Attachment 12 –Shellharbour Development Control Plan 2013 Assessment

Section 4.15 (1) (A)(lii) – Shellharbour Development Control Plan 2013

Figure 1 – Landscape Plan

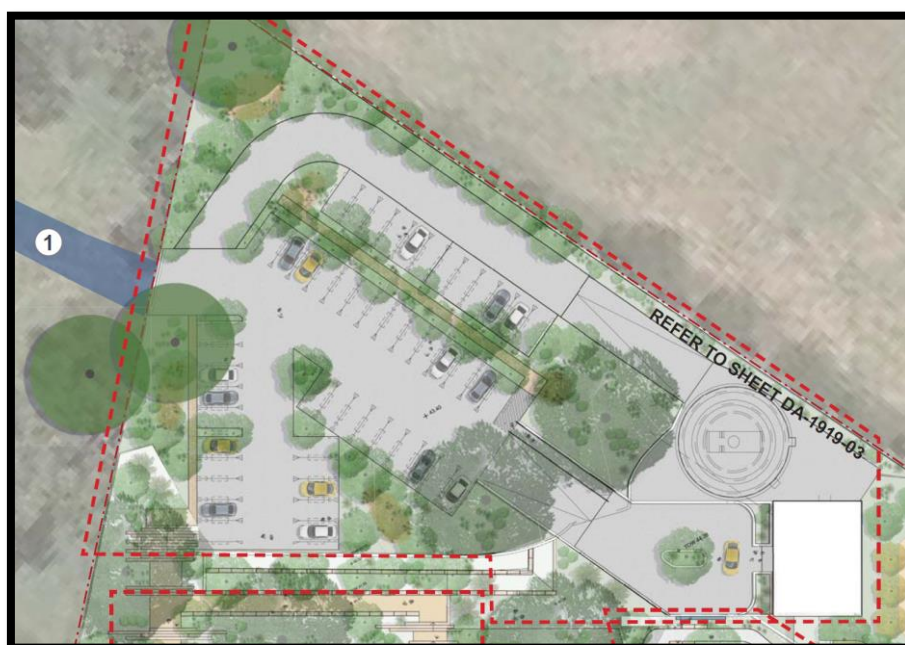
The car parking arrangement retains the existing mature Fig Trees that are located around the entrance to the site (Figure 1 below). The original parking design utilised impervious materials which has been removed from the design with the subsequent iteration (current) utilising a change to impervious surface treatment. This change of material choice conflicts with the original intention of protecting the mature Fig Trees. To ensure the Fig Trees are retained a condition is recommended to be imposed for the area contained under the tree canopy to utilise tree protection measures and permeable surfaces.
